APPLICATION NO.	FILING DATE	FIRST NAMED INVENTOR	ATTORNEY DOCKET NO.	CONFIRMATION NO.
10/707,908	01/23/2004	Jason M. Benz	BUR920030121US1	1907
29154	7590	08/14/2006	EXAMINER	
FREDERICK W. GIBB, III GIBB INTELLECTUAL PROPERTY LAW FIRM, LLC 2568-A RIVA ROAD SUITE 304 ANNAPOLIS, MD 21401			RUGGLES, JOHN S	
			ART UNIT	PAPER NUMBER
			1756

Office Action Summary	Application No.		Applicant(s)	
	10/707,908		BENZ, JASON M.	
	Examiner		Art Unit	
		John Ruggles	1756

DETAILED ACTION

FIG 4A

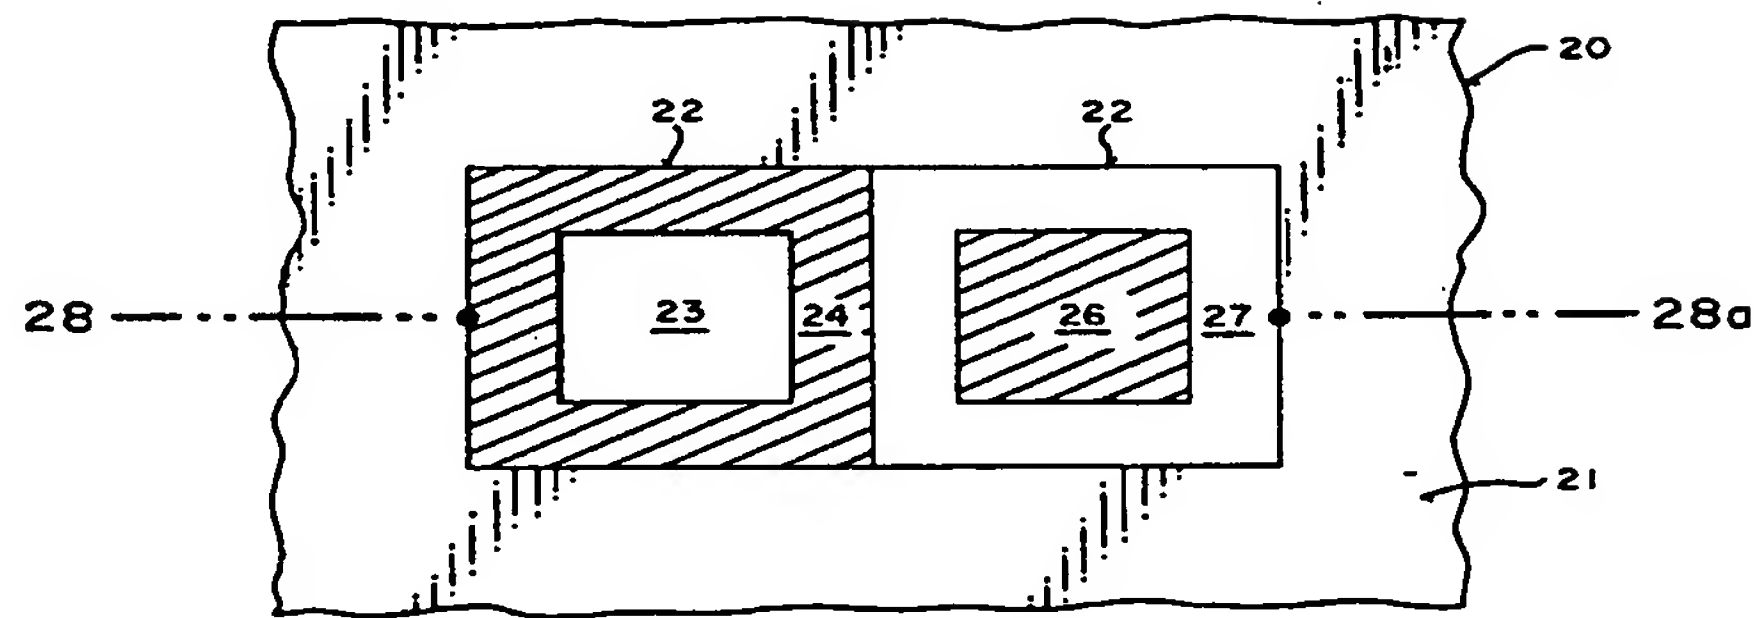
Dao et al. teach an inverted phase-shifted reticle or mask (PSM) having adjacent inverted phase features with PS rims or phase edges between 0° and 180° phase features; and methods of fabricating the PSM (title, abstract). The methods of fabricating the PSM include performing first patterning or etching of an opaque chrome (Cr) mask layer 21 (*instant claims 4 and 18*) formed on a transparent quartz substrate 20 (as shown in Figure 7, *instant claim 5*) to expose a first region of the transparent substrate 20, which is etched to form a PS region 53 first opening (Figure 8, which also corresponds to 24 in Figures 10 and 4A). This is followed by performing additional second patterning or etching of the opaque Cr layer to expose an adjacent second region 27 of the transparent substrate to enlarge the first opening formed in the first region 24 (*instant claims 2 and 16*) over a continuous area of the transparent quartz substrate (as shown in Figure 4A, which clearly depicts Figure 10 without any Cr between directly adjacent first region 24 and second region 27, col. 8 line 46 to col. 9 line 13, *instant claims 3 and 17*). In the PSM shown by Figure 4A, a first (etched PS) rectangular region 24 is directly adjacent to a second (unetched non-PS) rectangular region 27, in which both the first rectangular region 24 and the second rectangular region 27 are similarly shaped and sized (col. 5 line 67 to col. 8 line 3, *instant claims 1, 6, 15, and 19*).

Throughout the arguments on pages 9-18 of 19 in the amendment filed on 6/13/06, Applicant seems to have been confused regarding the order of process steps taught by Dao et al. for forming a PSM having a first PS region 24 (shown as 53 in Figure 8) and a subsequently formed second non-PS region 27 directly adjacent to 24 (as shown in Figure 4A), in which both

FIG. 1A
PRIOR ART

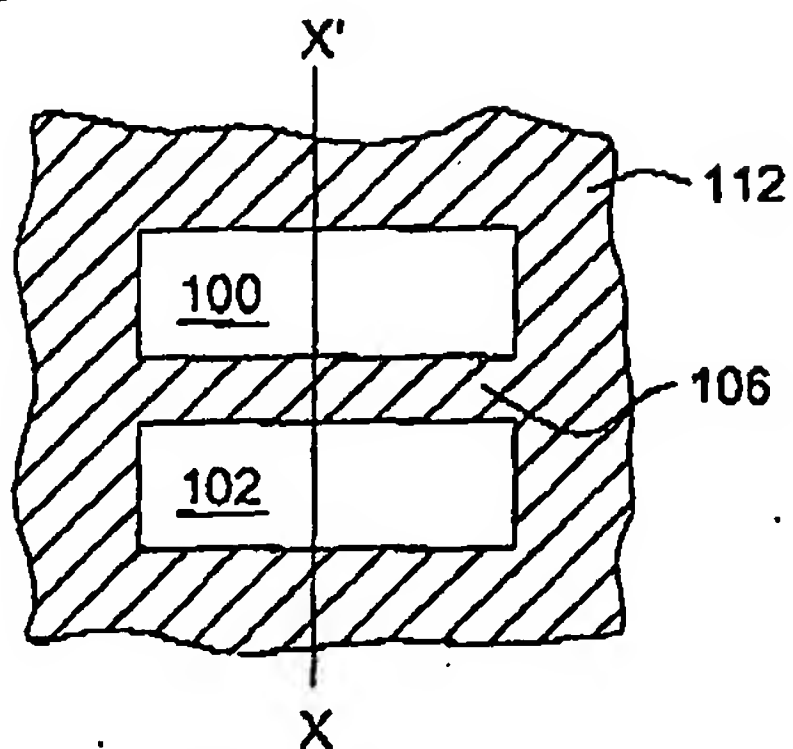
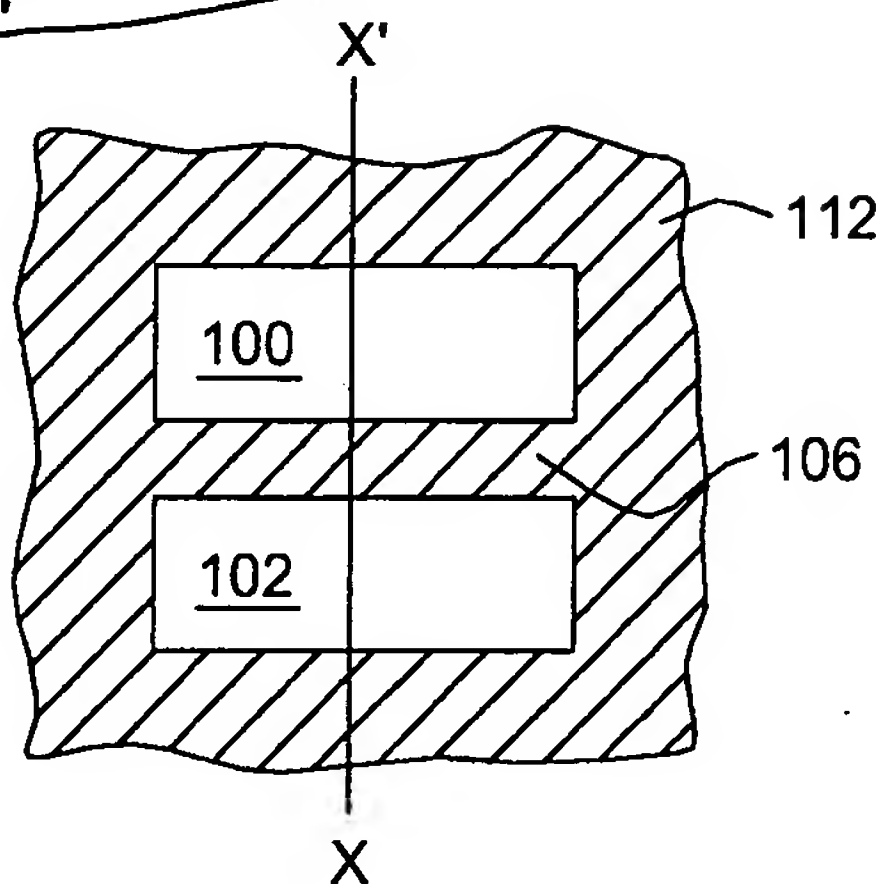
Applicant's proposed replacement drawings filed on 6/13/06 by fax and again in cleaner form on 6/14/06 electronically would address the reasons for the previous objections, but they are not in compliance with 37 CFR 1.121(d), because the proposed replacement sheets have not been labeled "Replacement Sheet" in the page header (as per 37 CFR 1.84(c)). Therefore, these proposed replacement drawings have not been entered and the previous drawings objections are maintained, as shown below.

Figures 1A-3B should be designated by a legend such as --Prior Art-- because only that which is old is illustrated. Paragraph [0018] indicates that the instant invention is an improvement on the methodology illustrated by Figures 1A-3B (even if this methodology is not necessarily well known). See MPEP § 608.02(g). The replacement sheet(s) should be labeled "Replacement Sheet" in the page header (as per 37 CFR 1.84(c)) so as not to obstruct any portion of the drawing figures. If the changes are not accepted by the examiner, the applicant will be notified and informed of any required corrective action in the next Office action. The objection to the drawings will not be held in abeyance.
